UNITED STATES PATENT AND TRADEMARK OFFICE

APPLICATION NO.	FILING DATE	FIRST NAMED INVENTOR	ATTORNEY DOCKET NO.	CONFIRMATION NO.
10/023,082	12/17/2001	Ichiro Fujieda	15168	7772
23389	7590	03/01/2004	EXAMINER	
SCULLY SCOTT MURPHY & PRESSER, PC 400 GARDEN CITY PLAZA GARDEN CITY, NY 11530			MACCHIAROLO, PETER J	
			ART UNIT	PAPER NUMBER
			2875

Office Action Summary	Application No.	Applicant(s)	
	10/023,082	FUJIEDA ET AL.	
	Examiner	Art Unit	
	Peter J Macchiarolo	2875

DETAILED ACTION

FIG. 1

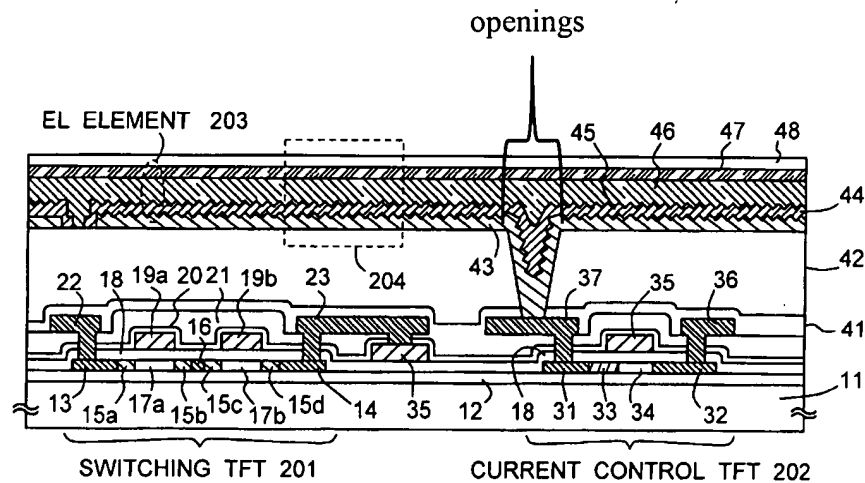
9. As broadly as claimed, Yamazaki anticipates claims 1 and 6. Yamazaki discloses in figure 1, a light emitting device having thin film transistor (TFT, 202) on an insulating base material (11); and above the TFT, a luminous section including a luminous material layer (46) and electrode layers (43, 44) supplying current to the luminous material layer; and a plurality of openings (below) in a predetermined pattern on a second insulating base material (42) and at least one material placed above the insulating base material (42) and below the luminous material layer, which is made of organic materials.¹

10. In regards to claims 4 and 9, Yamazaki discloses in figure 1, a light emitting device comprising a TFT (202) on an insulating base material (11); and stacked above the TFT, at least an insulating layer (42); a first electrode layer (47) to supply current to an organic luminous material layer (46), a second electrode layer (43), wherein the first electrode layer being made of

a transparent material, and the second electrode layer being made of a reflecting material,² a plurality of openings (above) on one of the insulating materials (42) and at least one material (44) placed above the insulating base material and below the luminous material layer, and the first electrode layer on convex sections of the insulating layer.

FIG. 1

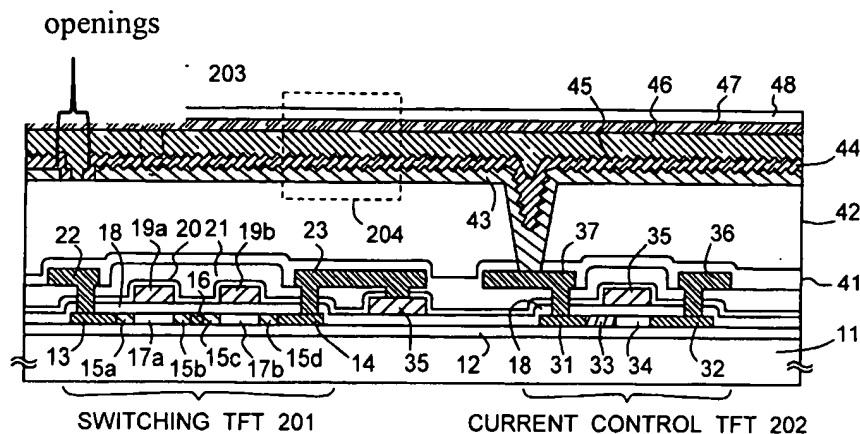
12. As broadly as claimed, Yamazaki teaches the limitations of claims 2 and 7. Yamazaki discloses in figure 1, a light emitting device comprising; stacked above an insulating base material (11), a first electrode layer (44) to supply current to an organic luminous material layer (46), and a second electrode layer (47) to supply current to the luminous material layer, a plurality of openings in a predetermined pattern (below) on the first electrode layer, and concavities and convexities formed on the luminous material layer and on the other electrode layer.

13. Yamazaki is silent to the first electrode being transparent.

18. In regards to claims 3 and 8, Yamazaki discloses in figures 1 and 3A, a light emitting device comprising; stacked above an insulating base material, at least a first electrode layer (47) to supply current to a luminous material layer (46), and a second electrode layer (44) to supply current to the luminous material layer, and the first electrode layer is made of a transparent material; the first electrode layer in plan view having a comb shape, and the luminous material layer, which is made of organic material, and the other electrode layer stacked on the electrode layer made of the transparent material are in the shape of concavities and convexities in side view.

19. Yamazaki is silent to the comb shape partly having circular regions.

22. In regards to claims 5 and 10, Yamazaki discloses in figure 1, a light emitting device comprising a TFT (202) on an insulating base material (11) and stacked above the TFT, at least an insulating layer (42) a first electrode (44) to supply current to an organic luminous material layer (46), a second electrode layer (47); the second electrode layer being made of a transparent material; the first electrode layer being made of a reflecting material, a plurality of openings (above) in a predetermined pattern on at least one of the insulating base material (42) and at least one material (43) placed above the insulating base material and below the luminous material layer, and the second electrode layer is on the luminous material layer.
